Well Name: OLD RANCH CANYON	Well Location: T22S / R24E / SEC 7 / NWNE /	County or Parish/State: EDDY / NM
Well Number: 1	Type of Well: OIL WELL	Allottee or Tribe Name:
Lease Number: NMNM81219	Unit or CA Name:	Unit or CA Number:
US Well Number: 3001528011	Well Status: Gas Well Shut In	Operator: OXY USA WTP LP

Type of Submission: Notice of Intent	Type of Action: Plug and Abandonment
Date Sundry Submitted: 11/07/2022	Time Sundry Submitted: 01:27
Date proposed operation will begin: 12/07/2022

NOI TO PLUG AND ABANDON WELLBORE 11/7/22

**Permanent Abandonment of Federal Wells  
Conditions of Approval**

## PROPOSED WELLBORE SCHEMATIC

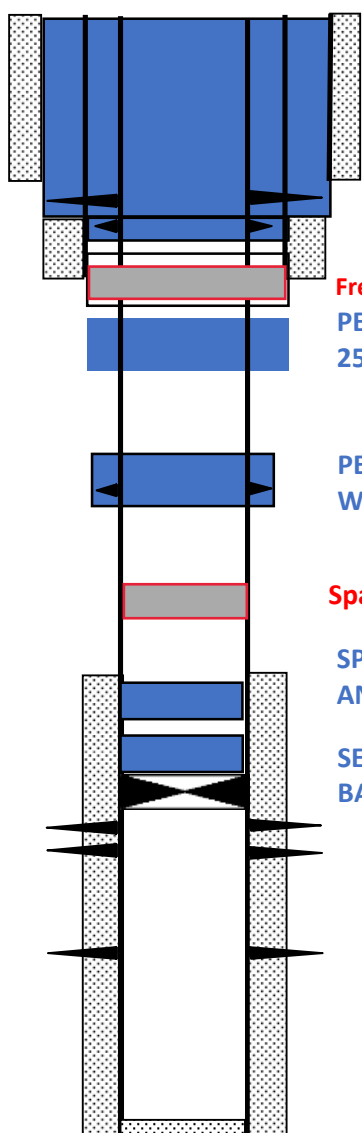
**PERF AT 530' WITH DEEP PENETRATION GUNS. EST CIRC UP INT AND PROD ANNULI. PUMP 400 SX CMT. VERIFY CMT TO SURF. Ensure cement to surface in both annuli**

**PERF AND SQZ 35 SX CMT 890'-790'.**

**Fresh water plug in the absence of Salt: 1550-1435'. 25sx Perf & Sqz. WOC & Tag**

**Spacer Plug (<3000' gap:) 5153' to 5000'. Spot 25sx**

**500psi, 30mins  
SET CIBP AT 7560'. LEAK TEST. DUMP  
BAIL 35 FT CMT. WOC AND TAG.**

Sundry ID		2701700				
Plug Type	Top	Bottom	Length	Tag	Sacks	Notes
Surface Plug	0.00	530.00	530.00	Verify circulated to surface in both annuli	400.00	TOC 9-5/8" at 530'. Operator bringing this plug to surface. Perf and sqz into both annuli
Shoe Plug	0.00	530.00	530.00	Verify circulated to surface in both annuli	400.00	TOC 9-5/8" at 530'. Operator bringing this plug to surface. Perf and sqz into both annuli
Fresh Water @ 1500	1435.00	1550.00	115.00	WOC and Tag	25.00	No salt interval/ plugs. Hence FW plug. Perf and sqz
Glorieta @ 2260	2187.40	2310.00	122.60	WOC and Tag	105.00	Same as below plug
Shoe Plug	2425.99	2551.00	125.01	WOC and Tag	105.00	Perf and Sqz
Bonesprings @ 3289	3206.11	3339.00	132.89	WOC and Tag	30.00	Perf and Sqz
Spacer plug	5000.00	5153.00	153.00		25.00	Spot
Wolfcamp @ 6917	6797.83	6967.00	169.17	WOC and Tag	25.00	
CIBP Plug	7525.00	7560.00	35.00	WOC and Tag	25.00	Leak test 500psi, 30mins

**No more than 2000' is to be allowed between plugs in open hole, and no more than 3000' between plugs in cased hole.**

**R111P: Solid plug in all annuli - 50' from bottom of salt to surface.**
